Renaissance Lot 1 Storm Drain - Update

CITY OF LAS VEGAS		DATE:
INTER-OFFICE MEMORANDUM		June 21, 2019
TO: Land Development Services Department of Building & Safety		FROM: Albert Sung, P.E. Flood Control Project Engineer Department of Public Works
SUBJECT: Drainage Study for: Renaissance Lot 1 Storm Drain - Update		COPIES TO: GCW Engineers / Surveyors
Cross Streets:	SEC of Alta Drive & Rampart Boulevard	RA Southeast Land Company
File Number:	F:\Depot\DSMemos\DS4991D.doc	Bart Anderson, P.E., DevCo
Parcel Number:	138-32-312-013	
Zoning Action:	TMP-71533	
FEMA Flood Zone	YES	NO X
Proposed Storm Drain	YES	NO X

**TECHNICAL DRAINAGE STUDY
UPDATE
FOR
RENAISSANCE LOT 1
(RENAISSANCE LOT 1 STORM DRAIN)**

Re: Update to the Technical Drainage Study for Renaissance Lot 1 (DS4991C)

DRAWING
SD-1
4 OF 6 SHTS

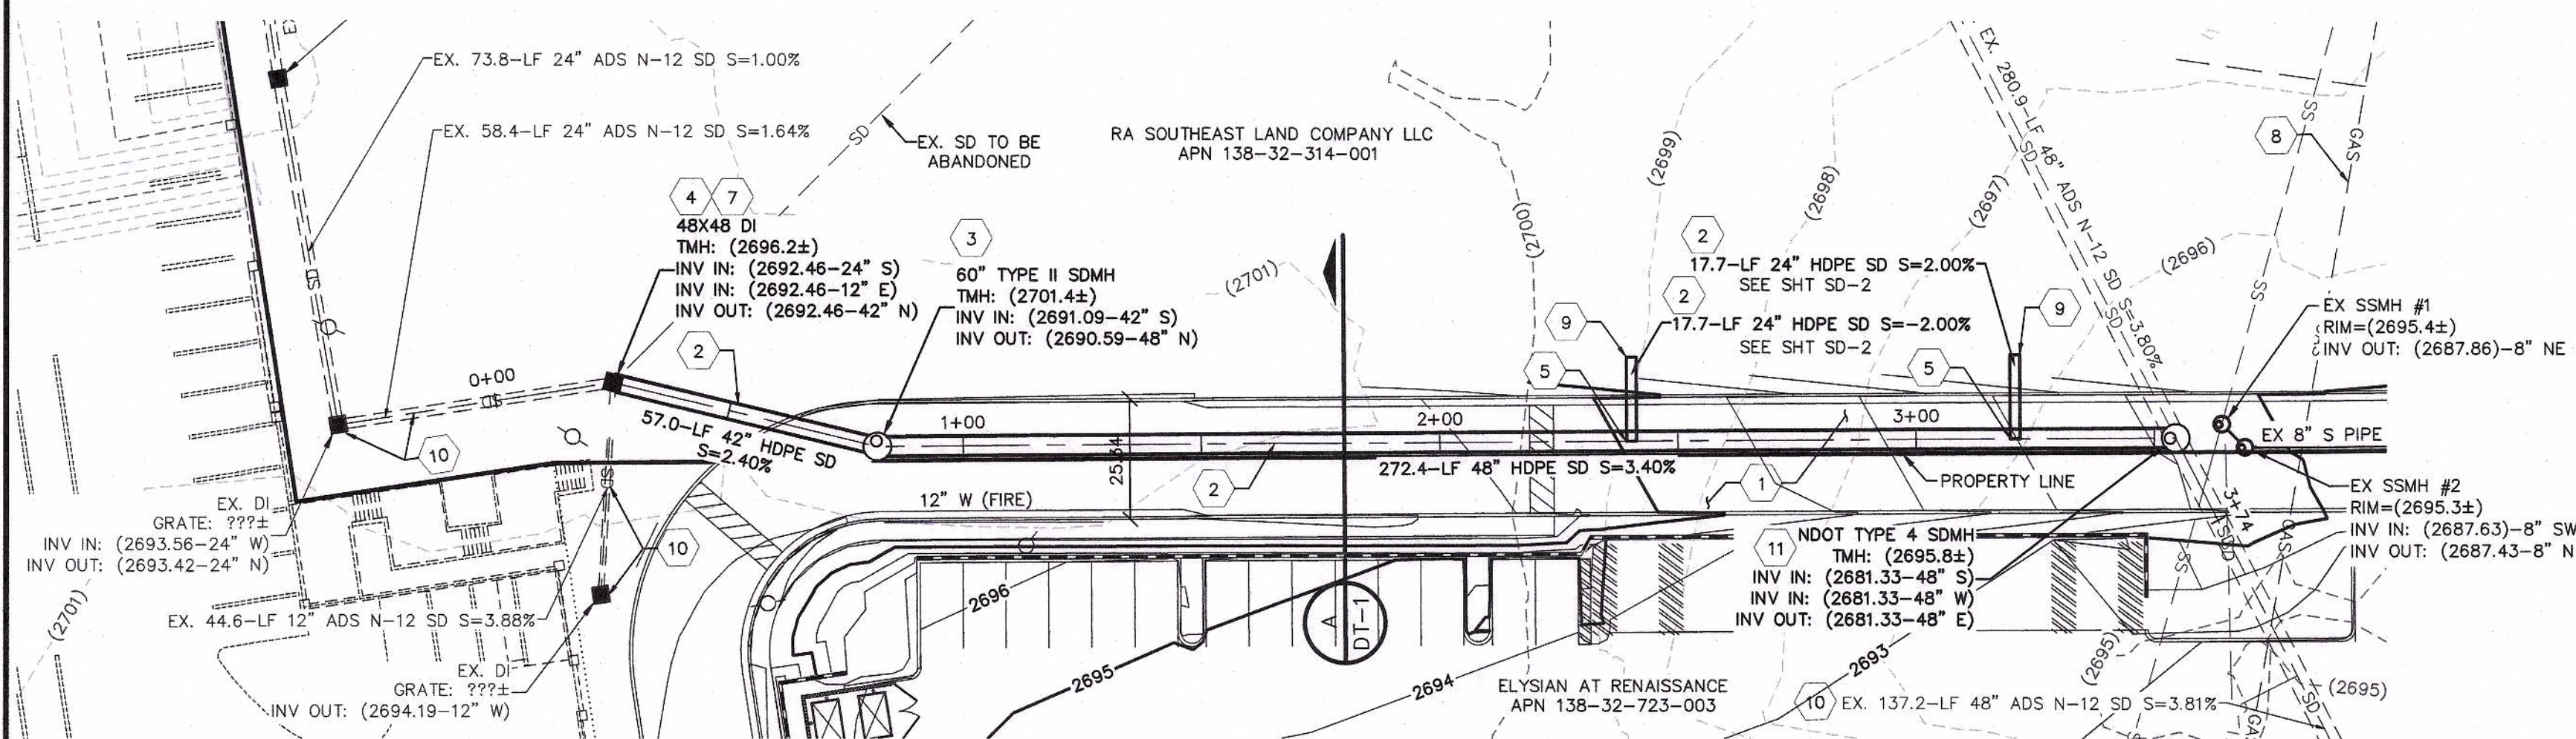
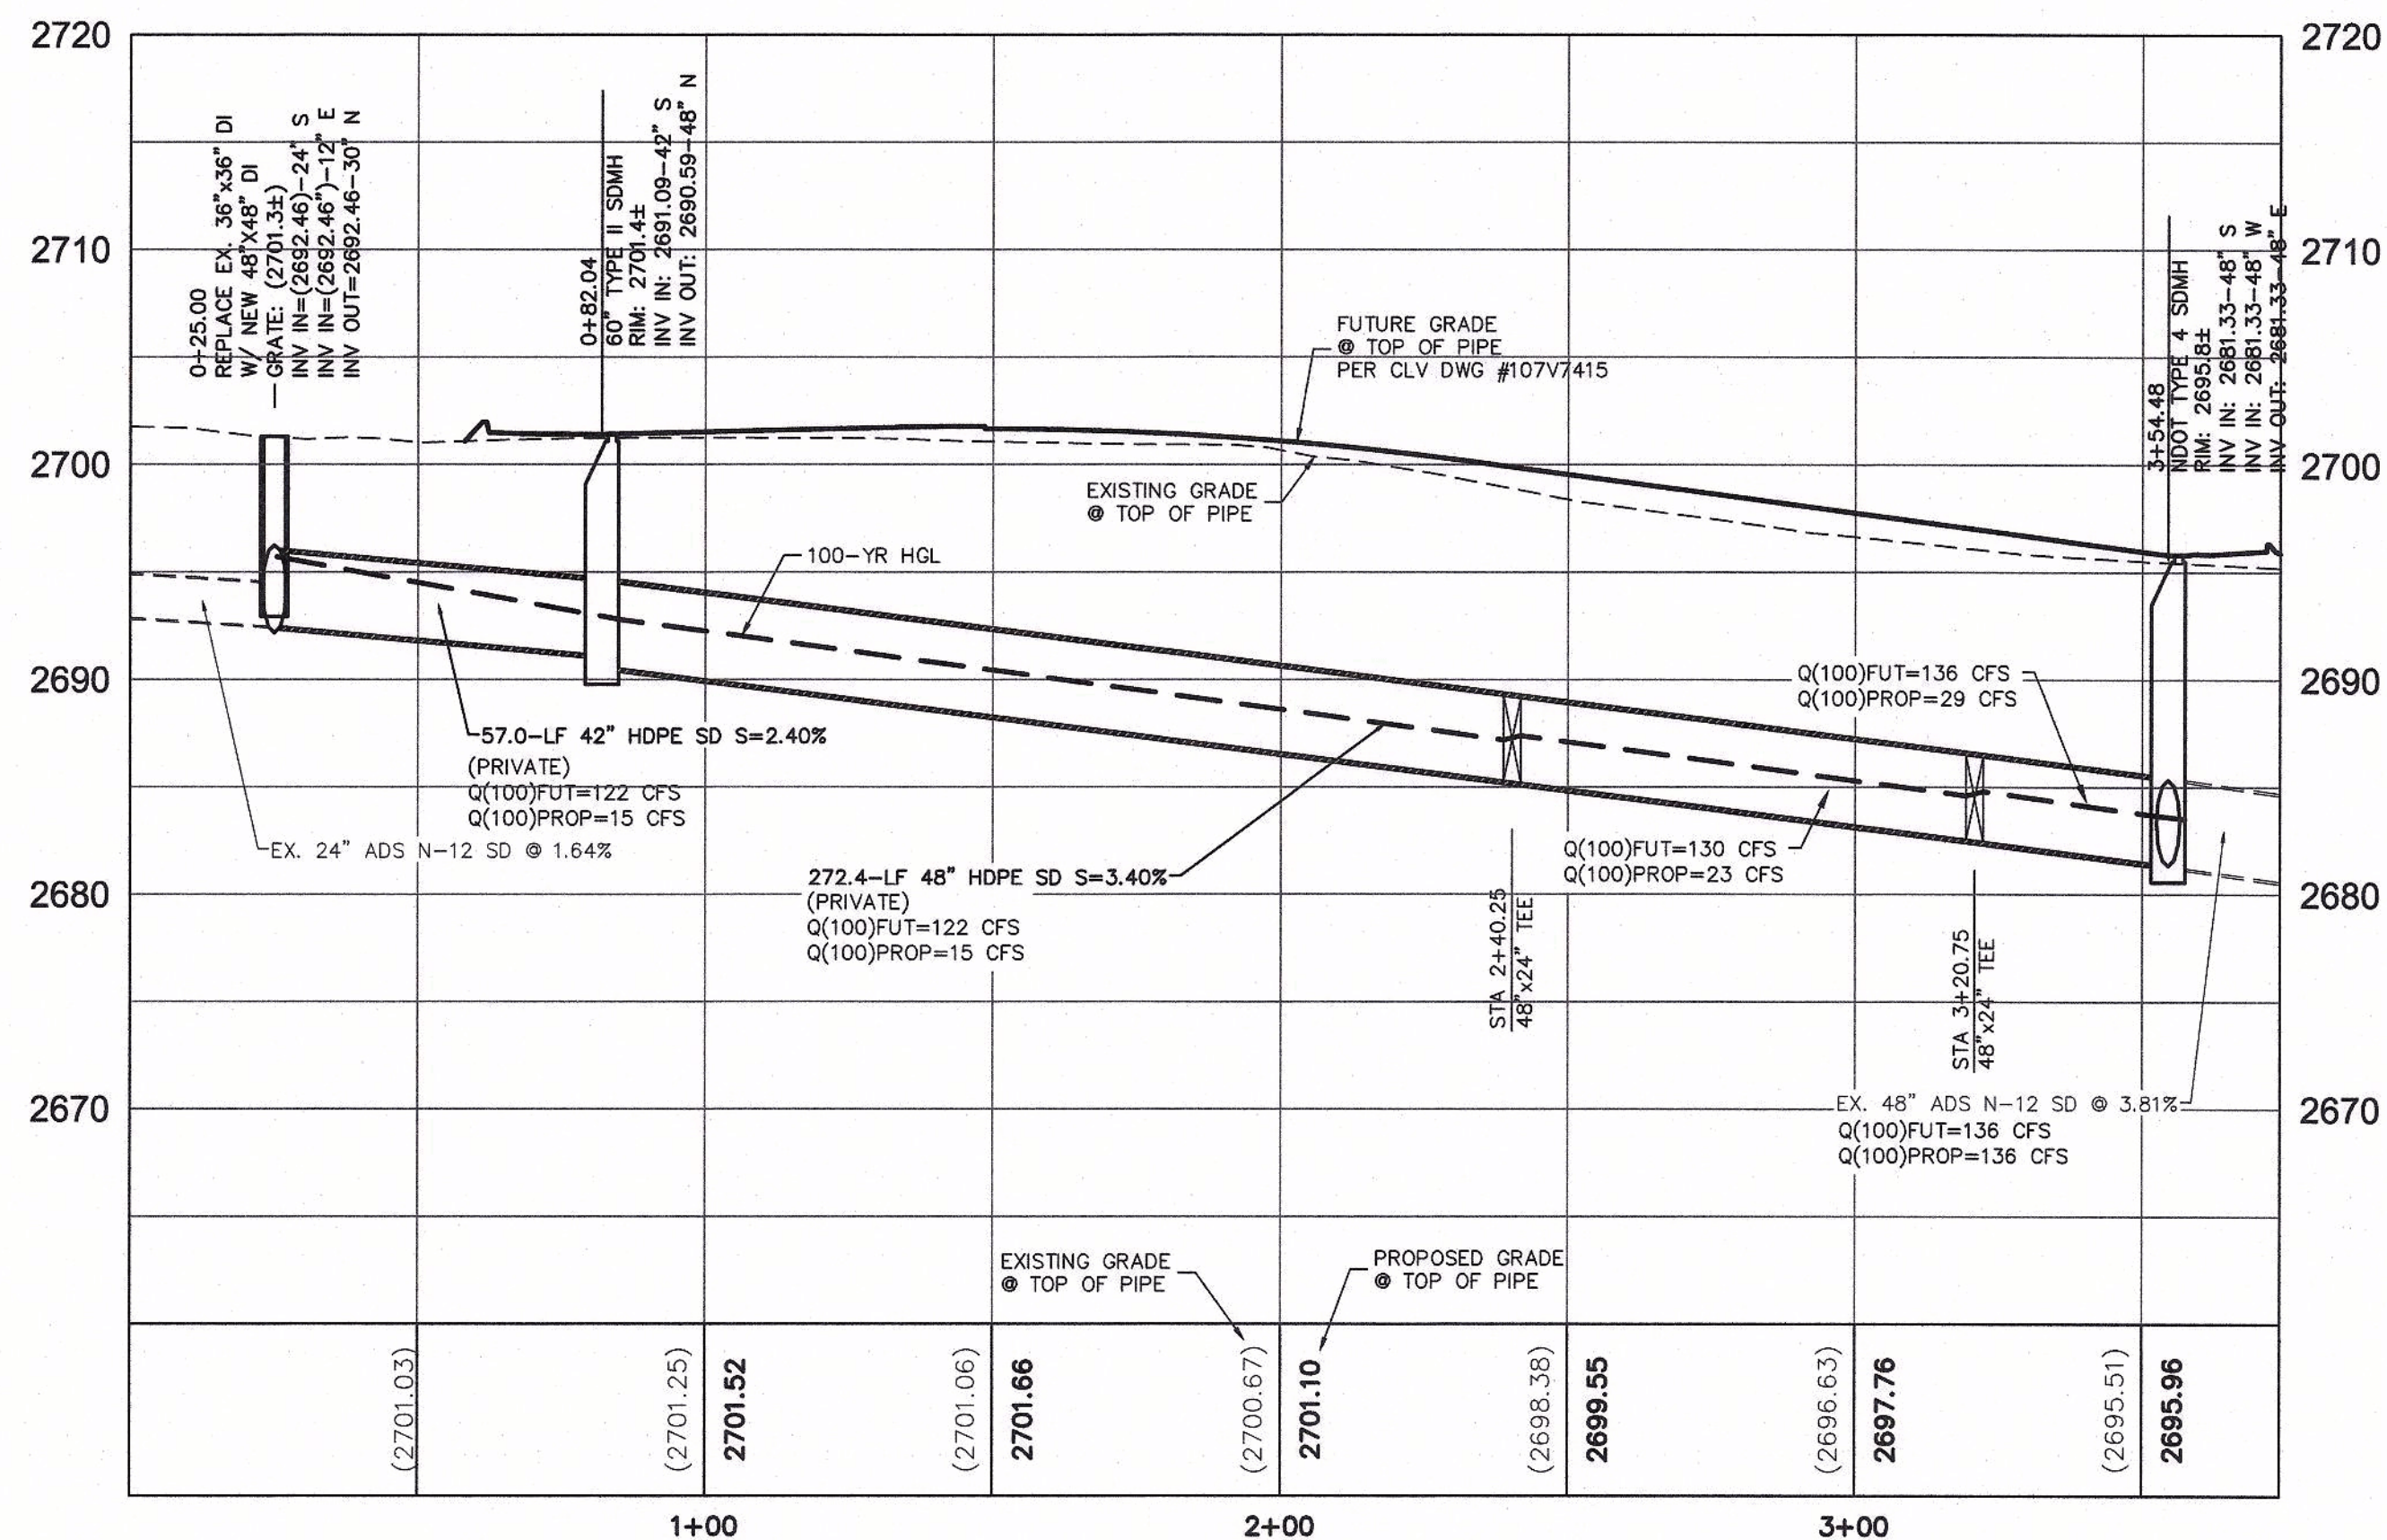
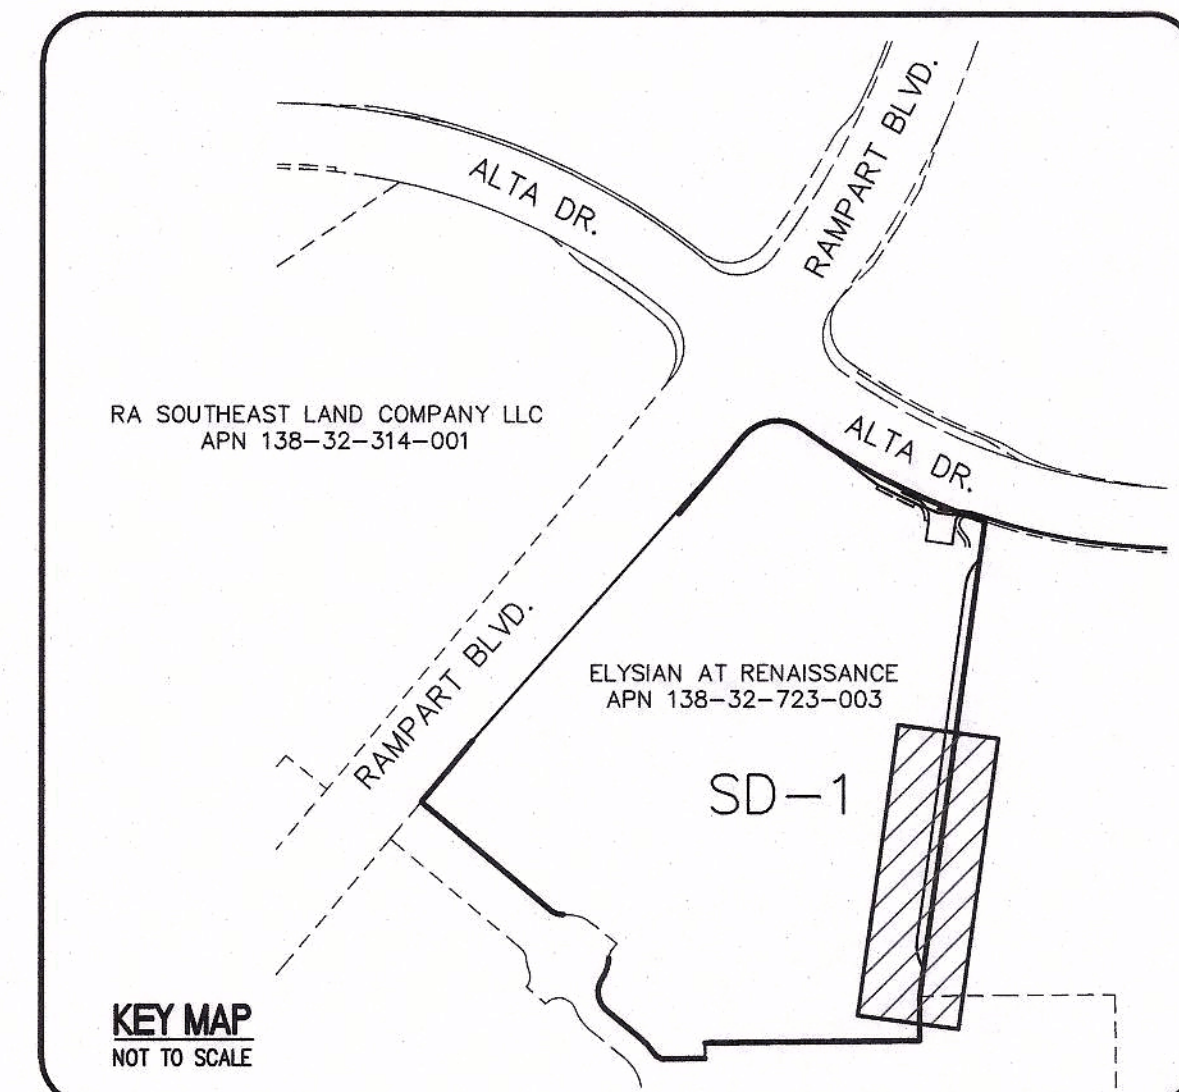
1. *City of Las Vegas* does not allow HDPE pipe in public right-of-ways or public drainage easements. Note that *City of Las Vegas* only allows the use of HDPE storm drain pipes for privately owned and privately maintained storm drain systems which serve and are located exclusively on private properties. Any proposed HDPE storm drain pipes must also meet all design criteria established by the *Clark County Regional Flood Control District* and must be installed per *Clark County Regional Transportation Commission Uniform Standard Drawings and Specifications*.
